**Oakdale CENTRAL Concept Plan (MP 08\_0065) and Estate Works + DJL Project Application (08\_0066)**  
**Response to Submissions Table**

## Attachment A – Riparian Zones

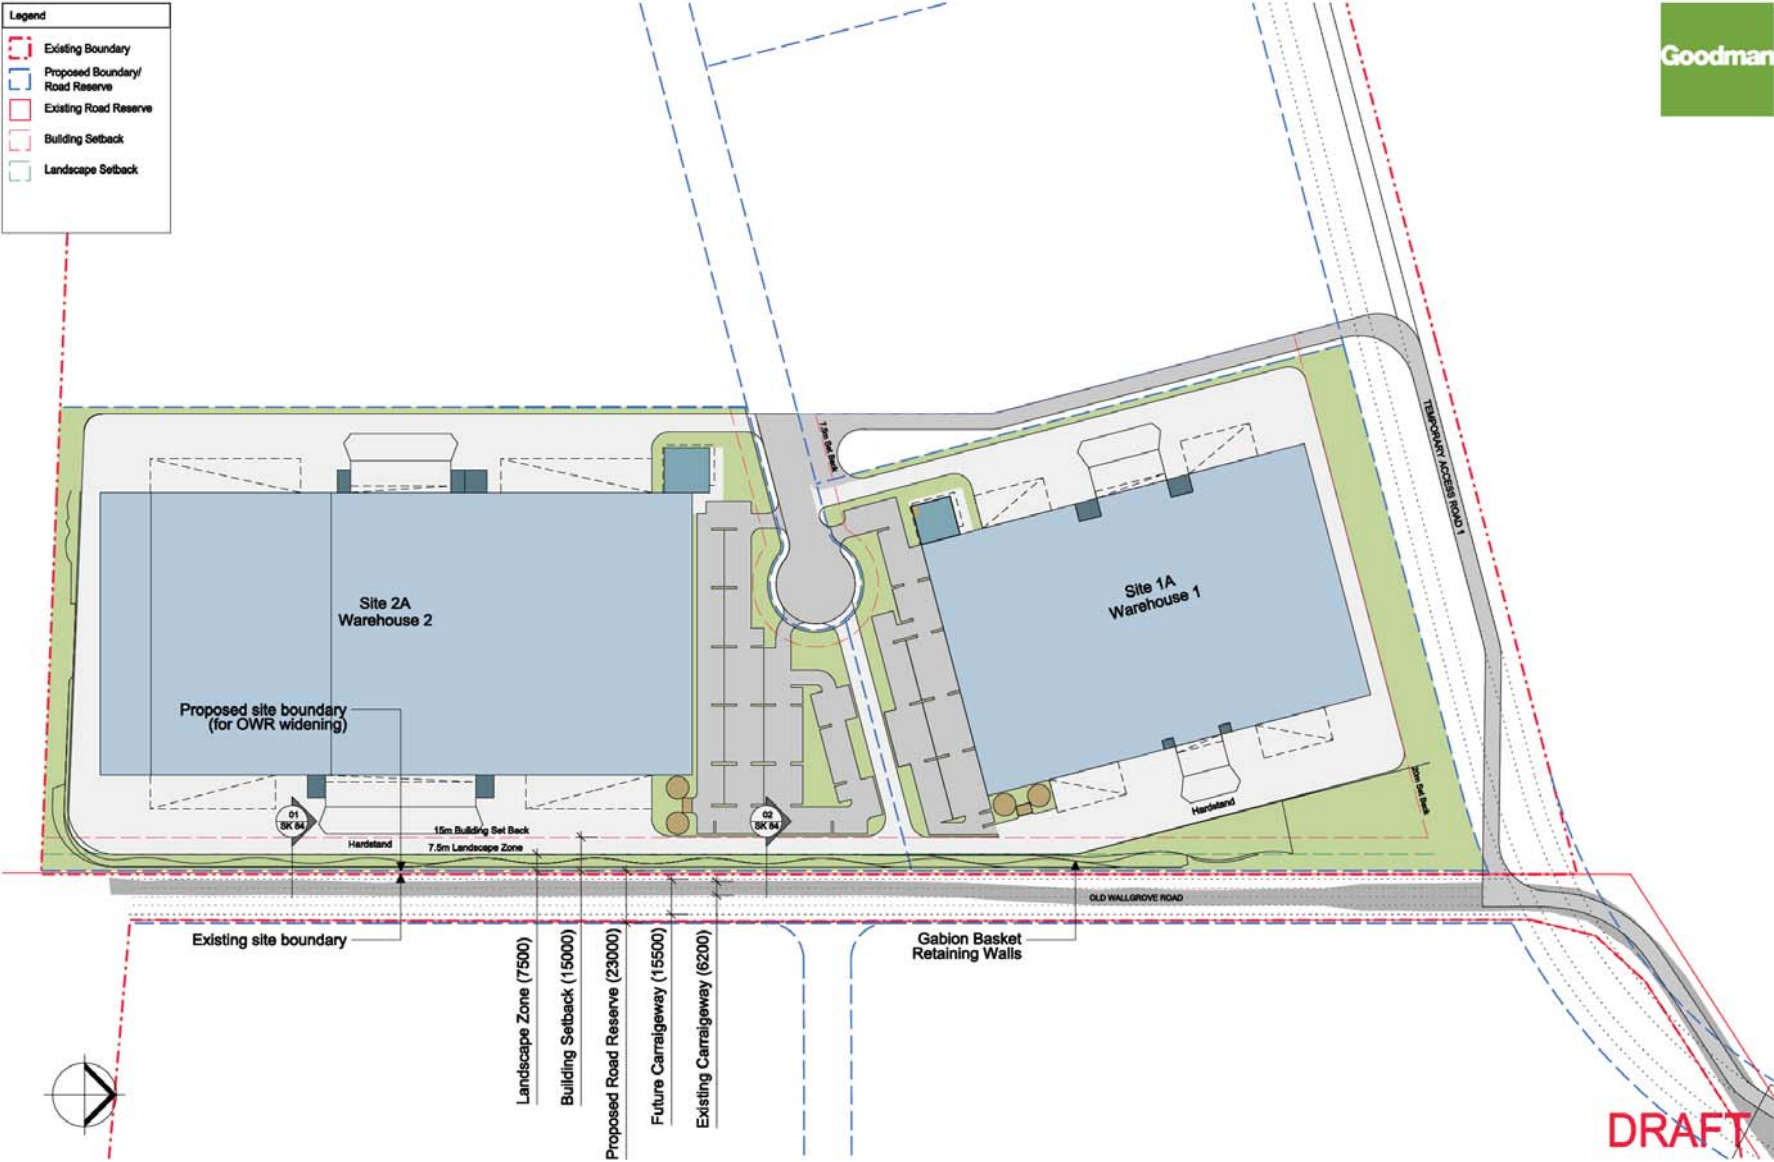
<b>Issue Title</b>	<b>Issue/Recommendation</b>	<b>Response</b>	<b>Action / Amendment</b>
<b>Government Agency Submissions</b>			
<b>Department of Environment and Climate Change</b>			
	DECC comments that it is able to support the proposal in its current form.	<ul style="list-style-type: none"> <li>No response required by Goodman.</li> </ul>	
<b>Department of Water and Energy</b>			
<i>Riparian Corridors</i>	DWE notes that the EA should be amended to include the Category 1 riparian zone in and around Ropes Creek at the southern end of <i>Oakdale SOUTH</i> .	<ul style="list-style-type: none"> <li>Goodman notes that <i>Oakdale SOUTH</i> is not the subject of the current application. DWE's comments in relation to this area will be considered in the finalisation of the planning for the wider <i>Oakdale ESTATE</i>.</li> </ul>	
	DWE comments that the EA needs to clearly demonstrate that the minimum riparian zones are achieved, and requests a scaled plan of the zones	<ul style="list-style-type: none"> <li>The proposed riparian areas are outlined in Section 4 of the Riparian Areas Assessment, and shown on the scaled building plans;</li> <li>A scaled plan showing the core riparian zone (CRZ) and outer riparian zone (ORZ) has been prepared in accordance with DWE's request (see Attachment A);</li> <li>See below for discussion on riparian zone widths.</li> </ul>	<ul style="list-style-type: none"> <li>Additional plan showing riparian zones prepared (see Attachment A)</li> </ul>

DWE recommends that only environmental protection works and crossings should be located in the riparian zones (CRZ and ORZ (or VB)), that detention basins should be located outside the riparian zones (CRZ and ORZ), that the full riparian zones (CRZ and ORZ) should be rehabilitated with native vegetation at a density that would occur naturally, and that all bushfire asset protection zones should occur outside the riparian zones (CRZ and ORZ).	<ul style="list-style-type: none"> <li>Goodman notes that DWE's recommendations are a departure from the riparian planning discussed with DWE (Greg Brady) during the site inspections for the project, a departure from the riparian area uses outlined in the Riparian Areas Assessment (prepared in consultation with DWE), and a departure from the Blue Book;</li> <li>Goodman understands that DWE's recommendations are based on its recently released <i>Guidelines for Controlled Activities – Riparian Areas</i> (February 08), which have been widely criticised by industry, and which are based on a different stream classification system than that in the Blue Book;</li> <li>Proposed landuses are outlined in Section 4.4 of the EA. The E2 Environmental Conservation zone equates to the core riparian area. The RE2 Recreation zone includes the ORZ. Proposed landuses within the CRZ and ORZ are also outlined in Section 4 of the Riparian Areas Assessment;</li> <li>As outlined, utility services (apart from crossings), stormwater management facilities, recreational facilities (generally), and bushfire asset protection measures would be located outside the CRZ, but potentially within the ORZ;</li> </ul>

Attachment C – Additional Old Wallgrove Road Landscape Treatment Plans

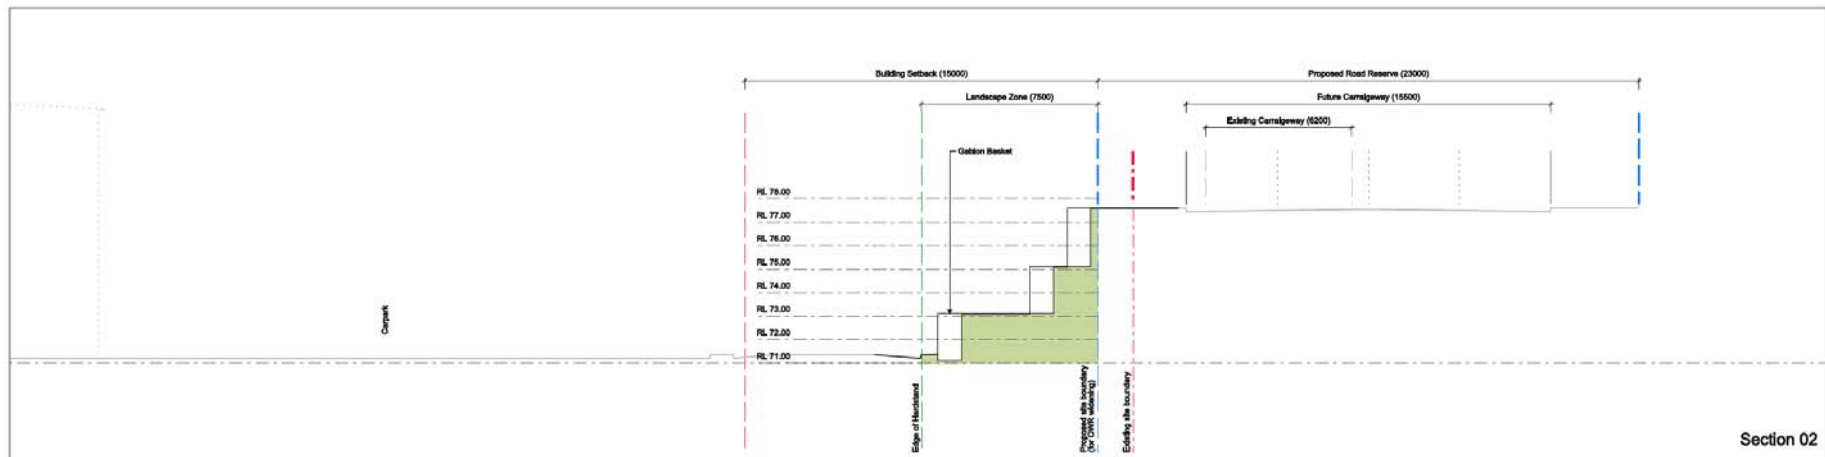
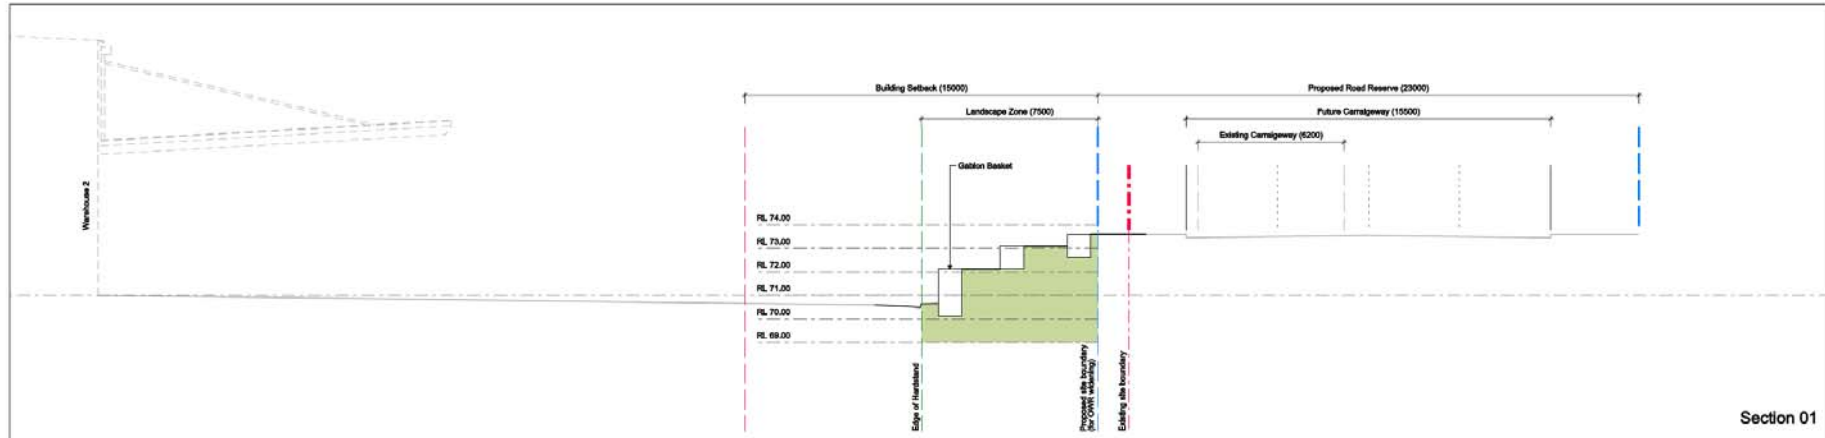
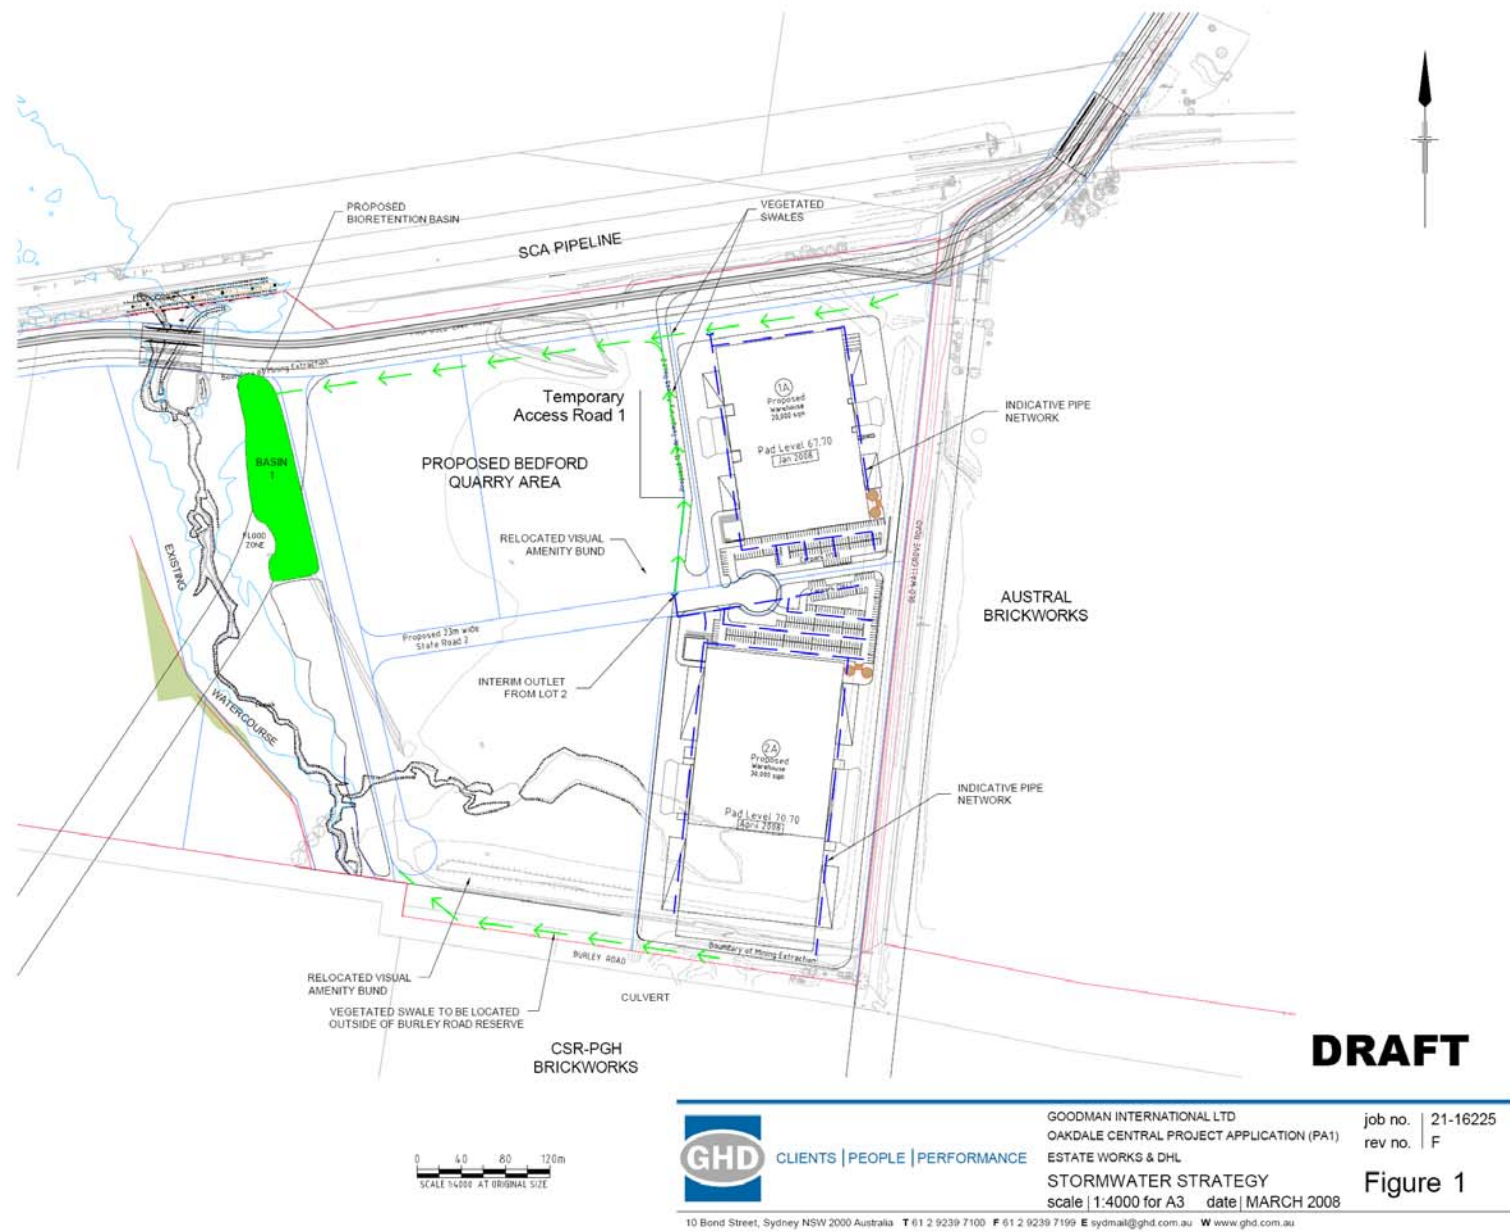
2. <i>Site Development Area and Landscaping</i>	Council recommends that a minimum 10 metre wide landscape zone be provided in the setback to Old Wallgrove Road, with a minimum 5 metre wide section provided at grade to Old Wallgrove Road to provide for street planting, cycleway and pedestrian access.	<ul style="list-style-type: none"> <li>Goodman notes that Old Wallgrove Road has been planned as a 'collector road' in the <i>CENTRAL Concept Plan</i>, unless it becomes the 'link road' if Option B is selected – which would be accommodated by additional setbacks in the <i>Oakdale EAST</i> (as shown on Figure 4.1 of the EA). The proposed standards for setbacks to collector roads are similar to those applied in Greystanes Estate and Eastern Creek by the applicable Precinct Plans – ie, a 15m building setback of which 50% or 7.5m is to be landscaped – not 10m as proposed by Council;</li> <li>Goodman has proposed a significant landscape treatment to road frontages throughout the <i>Oakdale ESTATE</i>, which is applied to the Old Wallgrove Road frontage of <i>Oakdale CENTRAL</i> – refer the Urban Design scheme drawings (by MacKenzie Pronk) and Landscape drawings (by Site Image) included in Volume 2 of the application documents. The urban design and landscaping proposed is a higher value design solution than simply setbacks for planting – the design proposed incorporates terraced retaining walls to accommodate level change in a coherent soft &amp; hard</li> </ul>	<ul style="list-style-type: none"> <li>Additional plan (SK.83(A)) and sections (SK84(A)) of the OWR Landscape Treatment prepared (see Attachment C)</li> </ul>

Issue Title	Issue/Recommendation	Response	Action / Amendment
		<p>landscape solution;</p> <ul style="list-style-type: none"> <li>An additional plan and cross-sections of the incorporated landscape / retaining wall are provided to illustrate the application of the urban design / landscape design proposed for road frontages of <i>Oakdale CENTRAL</i>;</li> <li>Goodman notes that Council's proposed 5m at grade landscape setback could potentially be provided, but this would require large vertical retaining walls which would compromise the landscaped solution and affect the visual amenity of the streetscape;</li> <li>Goodman does not believe that the provision of a cycleway and pedestrian footpath for Old Wallgrove Road on private land is reasonable. These should be provided within the road corridor as has applied in Greystanes Estate and Eastern Ck.</li> </ul>	
	Council recommends that a detailed landscaping plan be submitted to Council for approval prior to construction	<ul style="list-style-type: none"> <li>Goodman is happy to prepare a Final Landscape Plan, based on the plans in the EA, in consultation with Council. <i>DHL Project</i> commitment C.6.1 has been amended in this regard.</li> </ul>	<ul style="list-style-type: none"> <li><i>DHL Project</i> commitment C.6.1 amended to include preparation of final landscape plan in consultation with Council.</li> </ul>
